**Economic and Social Council**Distr.: General  
12 September 2022

**Economic Commission for Europe****Inland Transport Committee****World Forum for Harmonization of Vehicle Regulations****188th session**

**1958 Agreement:****Consideration of draft amendments to existing UN Regulations submitted by GRSG****Proposal for Supplement 4 to the original version of  
UN Regulation No. 151 (Blind Spot Information Systems)****Submitted by the Working Party on General Safety Provisions<sup>\*,\*\*</sup>**

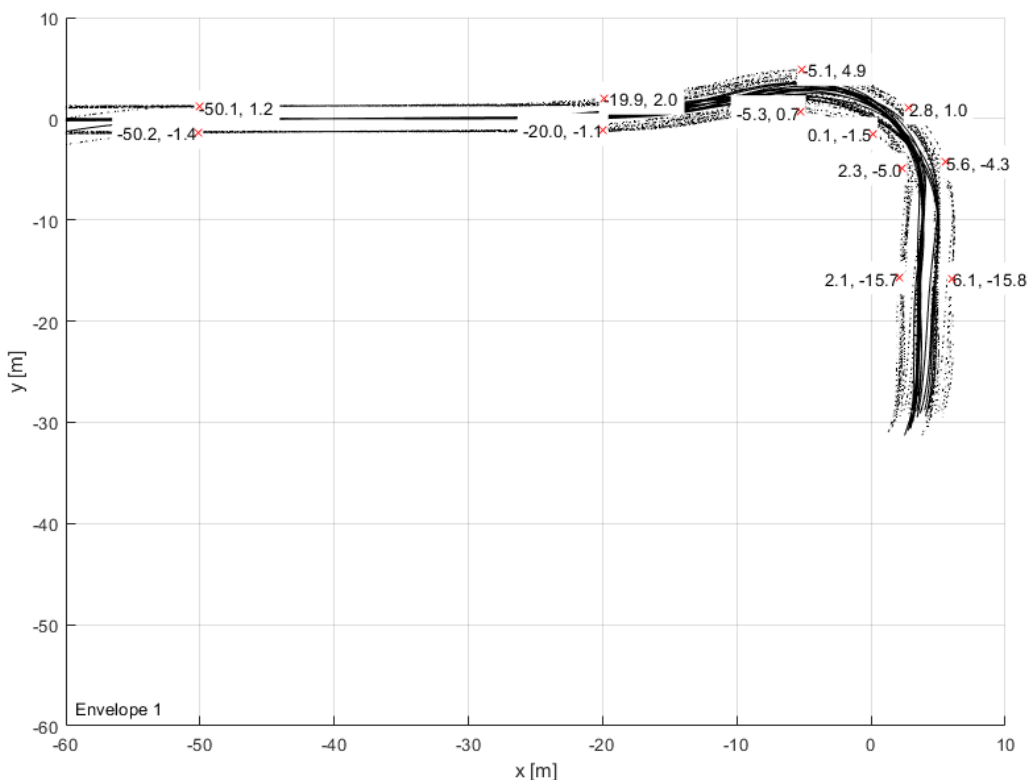
The position of the last point of information then is given by the first time where the following condition applies:

$$|d_{Bicycletrajectory}(t) - d_{brake,total}(t)| < 0.35 \text{ m}$$

**Envelope 2 (not considering the outlier test run):**

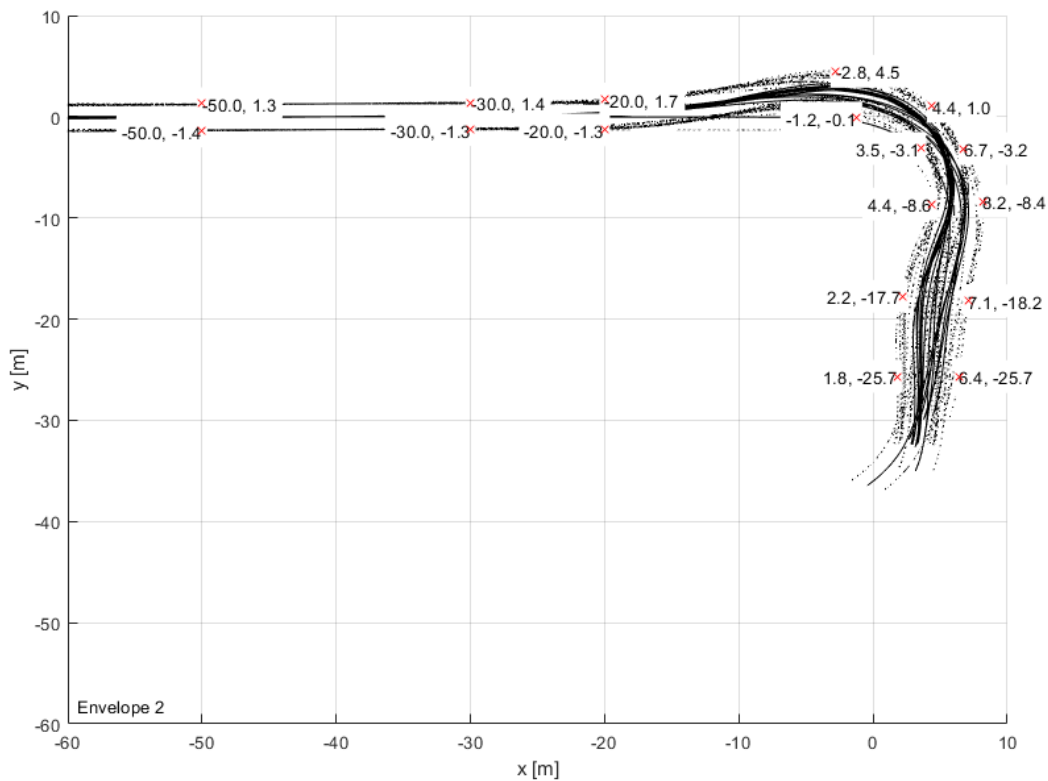
The vehicle shall be driven in such a way that the vehicle front is inside the dedicated points given for the respective envelopes in Appendix 1 at all times. This shall be verified with the measured data.
